21-1-21664-001

RE: DOCUMENT REVIEW SERVICES, MARINE DRIVE BINWALL RETAINING STRUCTURES, CITY OF WHITE ROCK, WHITE ROCK, BRITISH COLUMBIA

This letter report presents the results of geotechnical review services we completed for three existing steel binwall retaining structures located along Marine Drive between Cypress and Foster Streets in the City of White Rock, British Columbia (BC) (Figure 1). Our services included reviewing wall stability reports by Levelton Consultants and EBA Engineering Consultants. We reviewed a report by Levelton Consultants dated 20 June 2011, a report by EBA Engineering Consultants dated September 1994, and slope inclinometer data from Levelton Consultants dated 2011 and 2013. Our services also included review of BNSF station maps. At BNSF's request, we also reviewed historical documents and agreements pertaining to wall ownership and maintenance responsibility, including a copy of an indenture between BNSF and the City of Surrey dated 14 August 1950. We provided these services in general accordance with our proposal for services dated 26 March 2013. You authorized our services via signed request for task order dated 2 April 2013.

BNSF Railway Stability Review Services City of White Rock, White Rock, British Columbia	
BNSF STATION MAP EXCERPT	
May 2013	21-1-21664-001
SHANNON & WILSON, INC. <small>GEOTECHNICAL AND ENVIRONMENTAL CONSULTANTS</small>	FIG. 2 Sheet 1 of 3

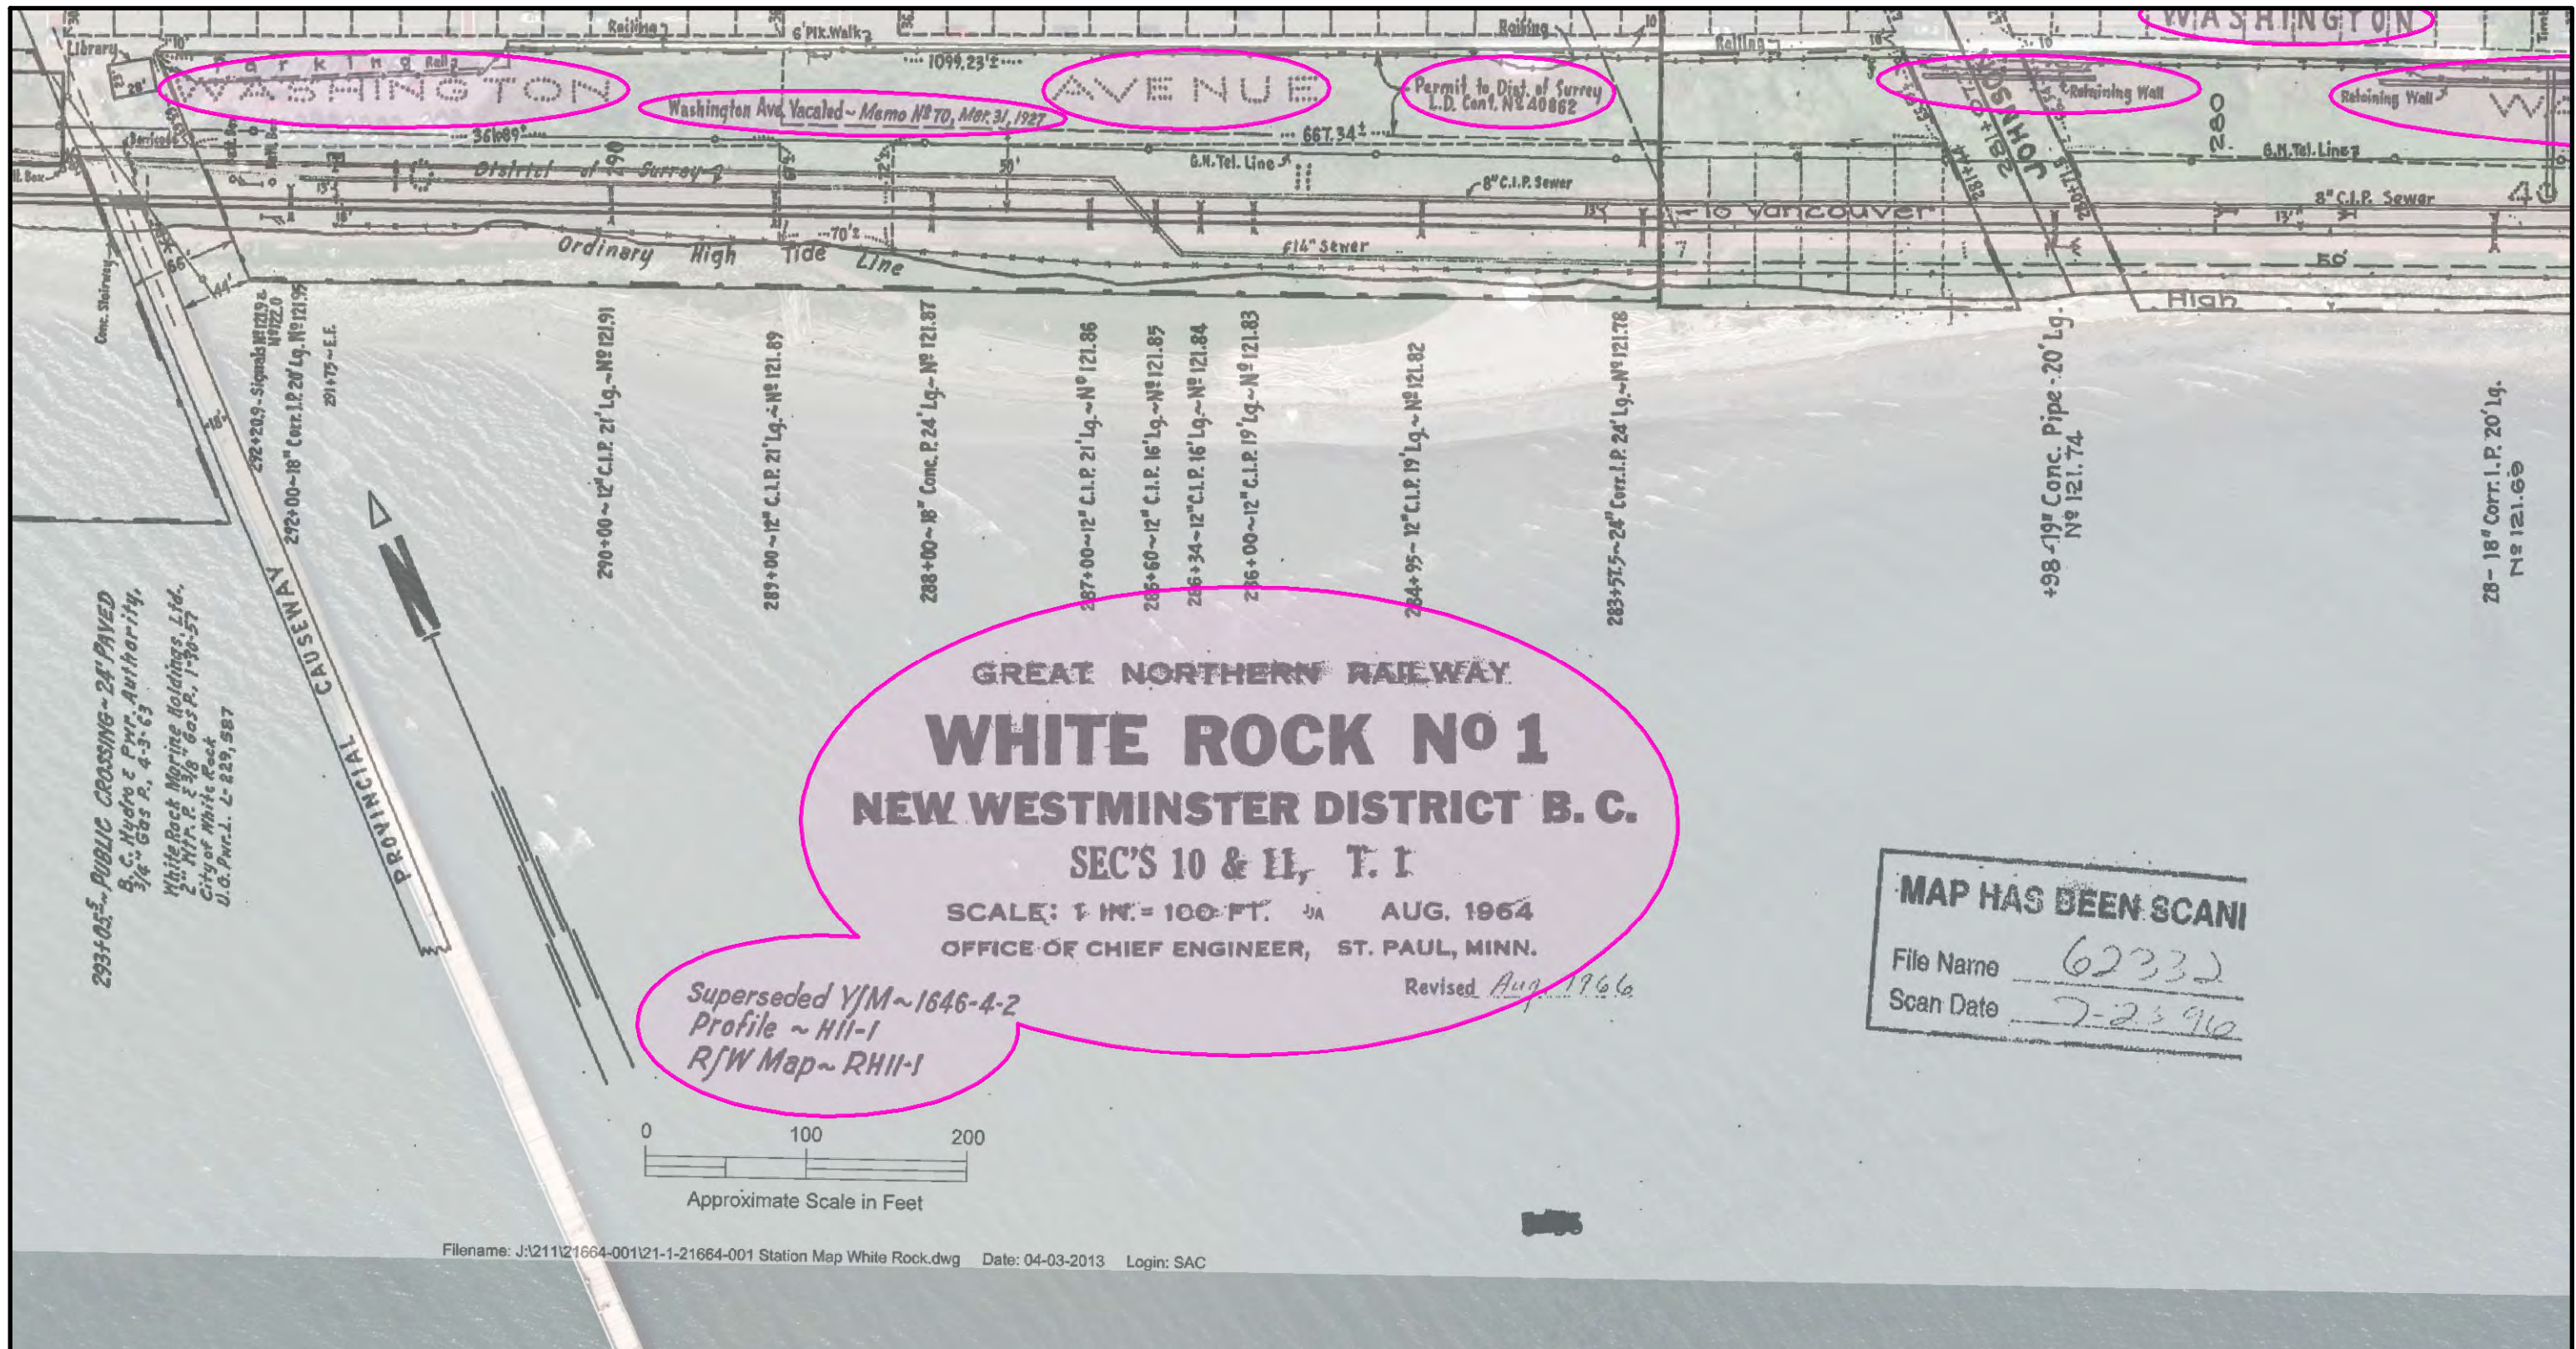
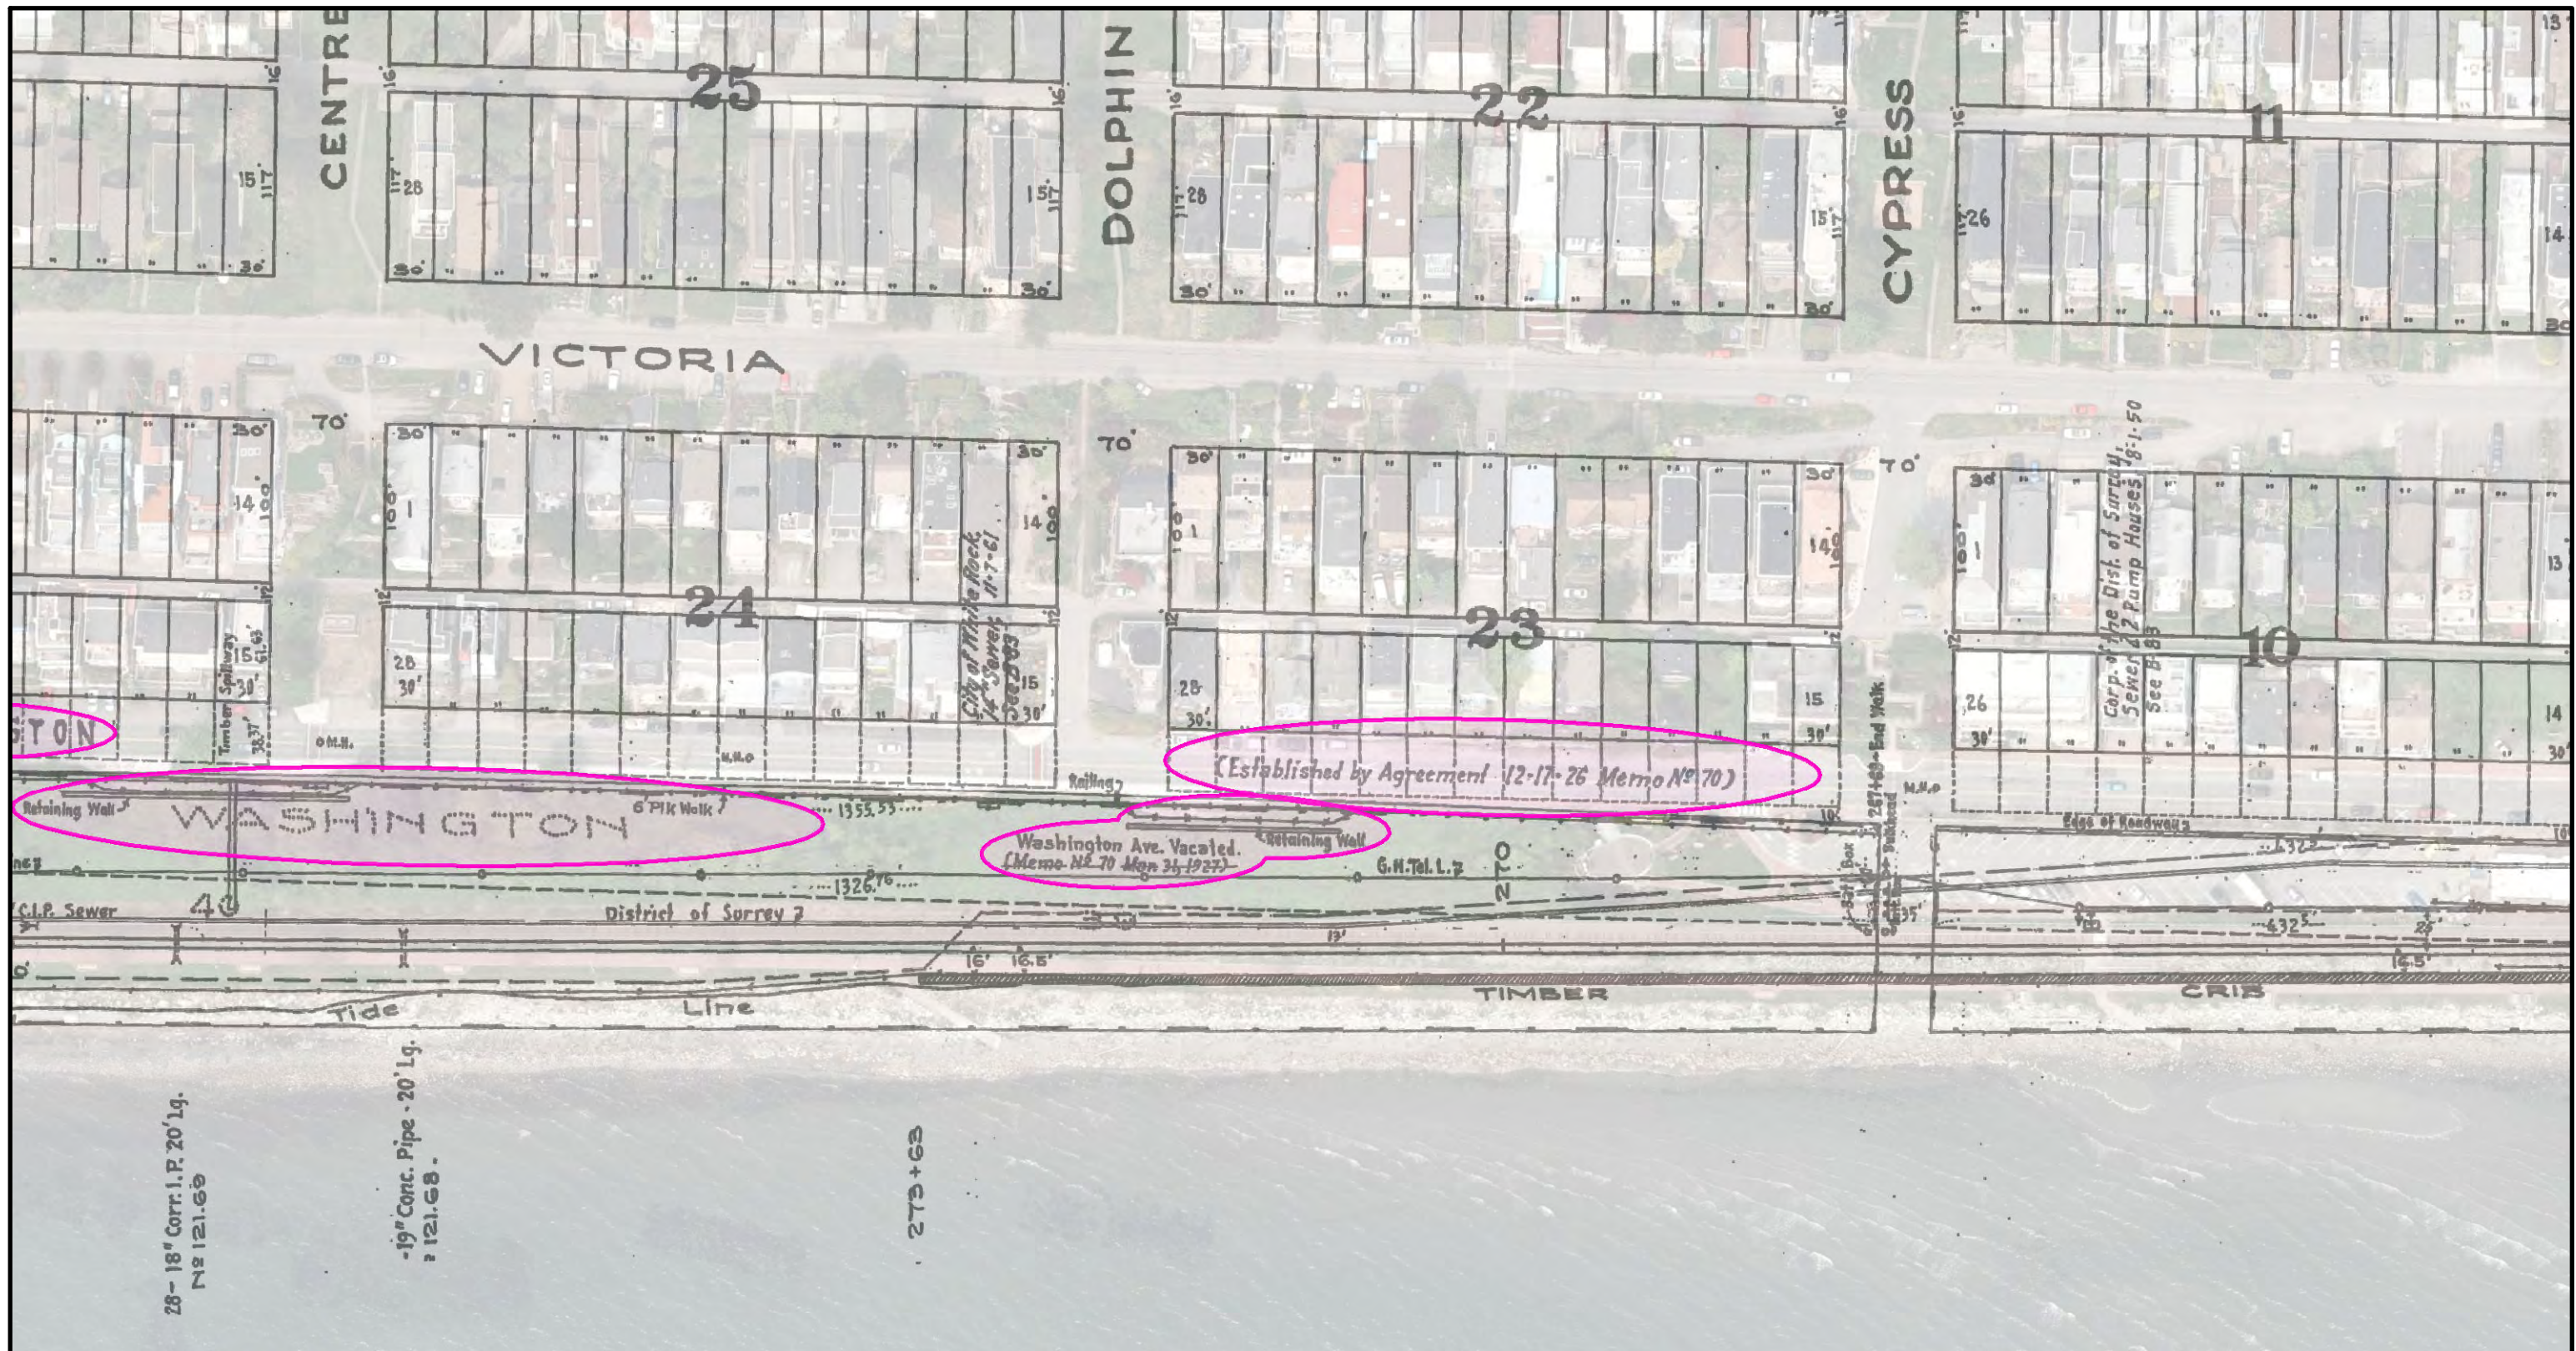
The station map (Figure 2) shows the tracks, right of way boundary, city streets, parcel boundaries, utilities, and other railway and City features. Retaining walls shown on the map match the approximate locations of the three walls at the project site. To compare the features on the map to present site features, we overlaid the map onto an aerial photograph (Figure 3). The photo and map do not match exactly, and the features depicted in the map should be considered approximate.

The approximate location of the right-of-way boundary is at the south edge of the sidewalk along the south side of Marine Drive. Though the three retaining structures are not clearly distinguishable in the aerial photo, those on the station map appear to correspond to the approximate locations described in the reports by Levelton and EBA.

There are many notes and markings on the map that allude to the history of the site. Several of the notes reference permits, contracts, and memos. Several of the notes and markings we identified include:

- Marine Drive is labeled Washington Avenue in the map.
- There are notes that indicate Washington Avenue was platted south of present-day Marine Drive, just north of BNSF tracks.
- Notes indicate Washington Avenue was vacated via memo: ***Memo No. 70, March 31, 1927.*** The same note appears to be lined-out elsewhere on the map.
- The area between sidewalk on south side of Marine Drive and lower slope is labeled as: ***Permit to Dist. Of Surrey L.D. Cont. No. 40862.***
- A note on the map indicates: L.D. Cont. No. 40862, Aug. 14, 1950, Ry. Co. grants Dist. of Surrey right to enter upon and construct bulkhead and road support to Washington Ave. (District to furnish conc. Pipe for three culverts).
- Separate note indicates: Established by Agreement 12-17-26 Memo No. 70

We also noted a marking near the station map title block that says *Superseded V/M~1646-4-2, Profile~H11-1, R/W Map~RH11-1.*
